Driveline Guard – Missing Brace on A3FE and BBCV Units

Service Notice #18-1109

Missing Brace May Cause Driveline to Contact Air Brake Components on A3FE and BBCV Units

Figure #1

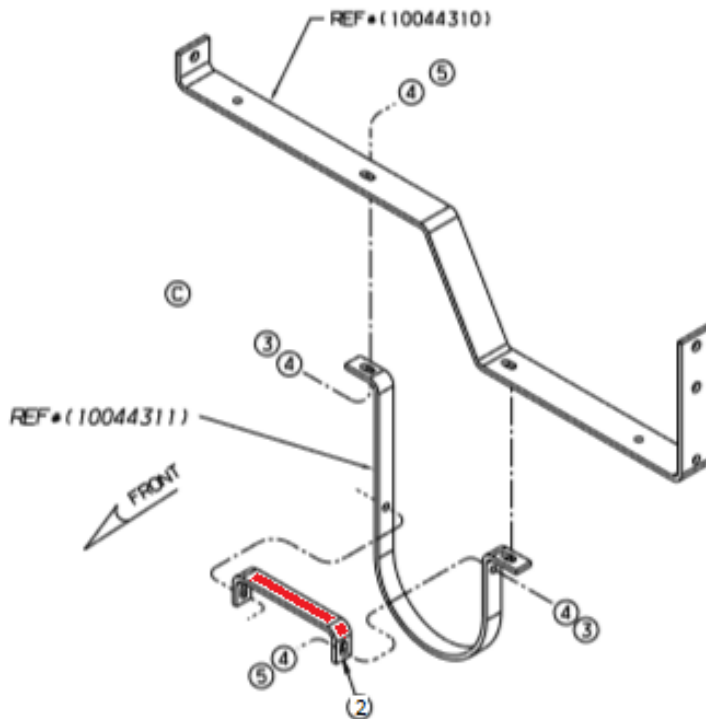
We have found that with a specific driveline guard configuration that a cross-brace was left off. Without this brace there is the possibility that the driveline could contact an air tank and air lines should the driveline break free.

The guard in question is shown in Figure #1 and is a “mid-mount” guard which is generally mounted to protect the center section of the driveline near the air tanks as in Figures #2 & #3.

Generally we have found that most units have the holes predrilled in the “loop” for the cross-brace and installing is a matter of bolting the brace (shown in red in Figure #1) and torquing the bolts to 29-33 ft/lbs.

TORQUE ITEM #5 29-33 FT-LBS.

Figure #4

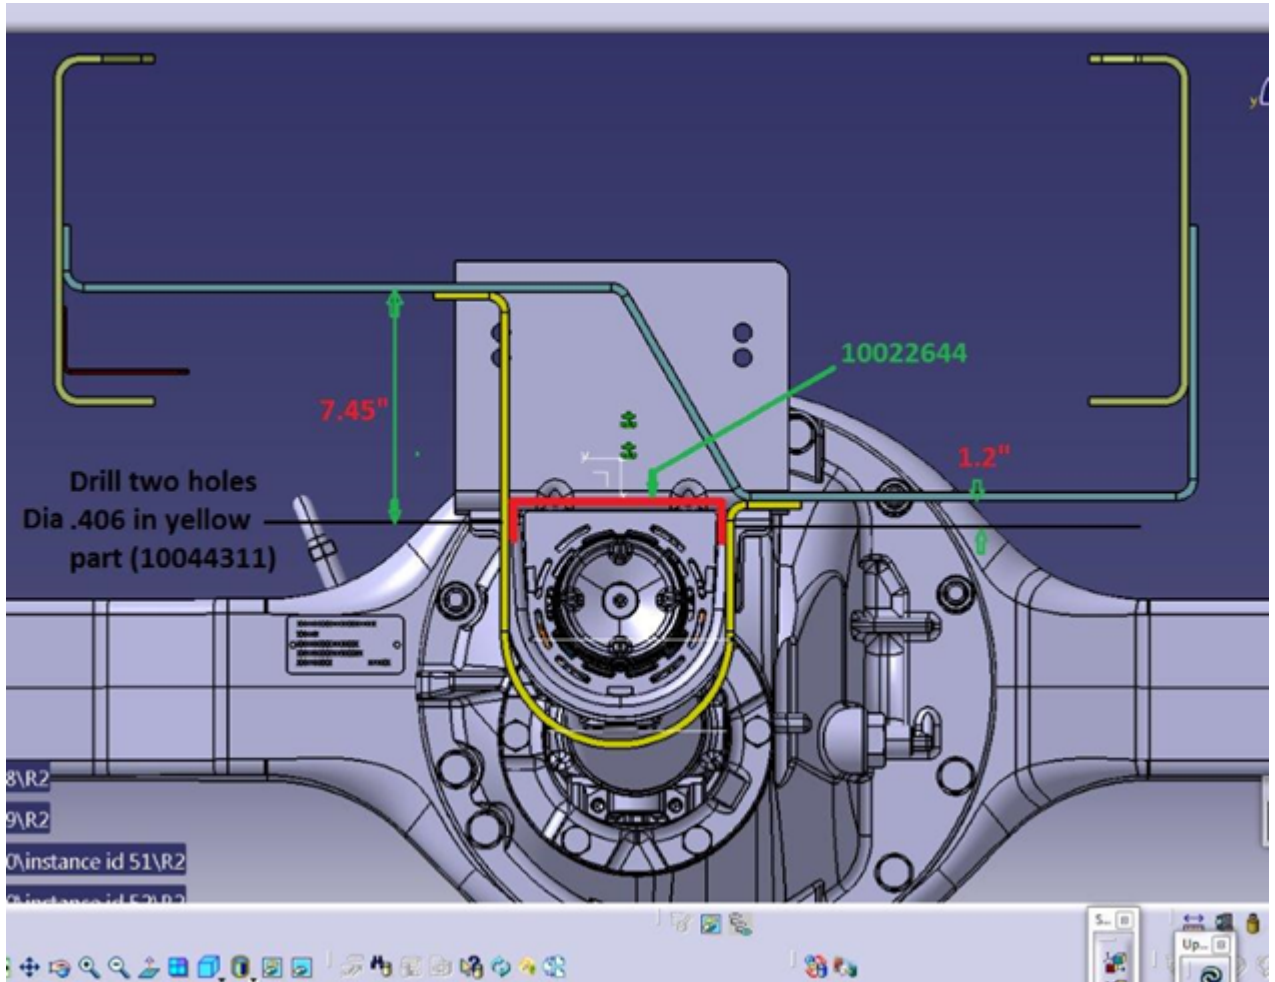
There is an added photo showing the brace placement in Figure #4 should holes need to be drilled.

BRACE PART #10022644
